Access Compliance Report

Public Rights-of-Way

(Pedestrian Signals)

Intersection ID: N/A	Main Street:	Cross Street: N/A	Location: N/A
ADA ID: 13DD480ADF51	Signal Type: One Push Button-Non APS	Overall Compliance: No	Severity Score: BTN 1: N/A BTN 2: N/A No BTN: N/A
Codes/Mitigation Info/Possible Solution		Field Measurements/Component Compliance

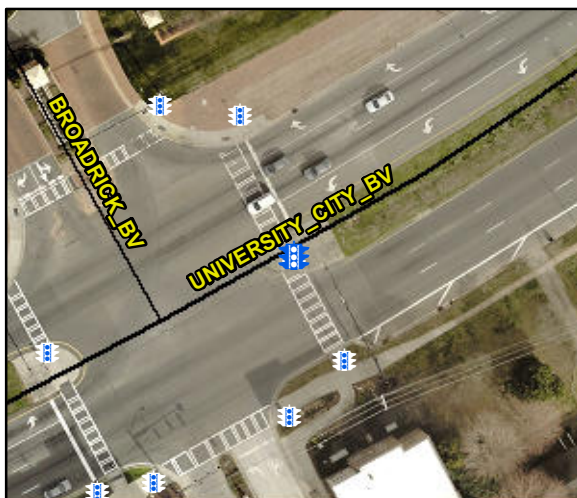
PROW/ADA: TMUTCD 4e.08, R404.2, R404.3, R404.7.3, R404.7.2

N/A	B 1 Clear Xing Direction?	Yes	N/A	B 2 Clear Xing Direction?	N/A
	B 1 Crossing Direction	To SE		B 2 Crossing Direction	N/A
Yes	B 1 DistanceTo XWalk (in)	0.0	N/A	B 2 DistanceTo XWalk (in)	N/A
No	B 1 DistanceTo Curb (in)	110.0	N/A	B 2 DistanceTo Curb (in)	N/A
Yes	B 1 Diameter (in)	2.0	N/A	B 2 Diameter (in)	N/A

Possible Solutions: Replace Signal Push Button With APS Button on New Post. Remove & Relocate Sign.
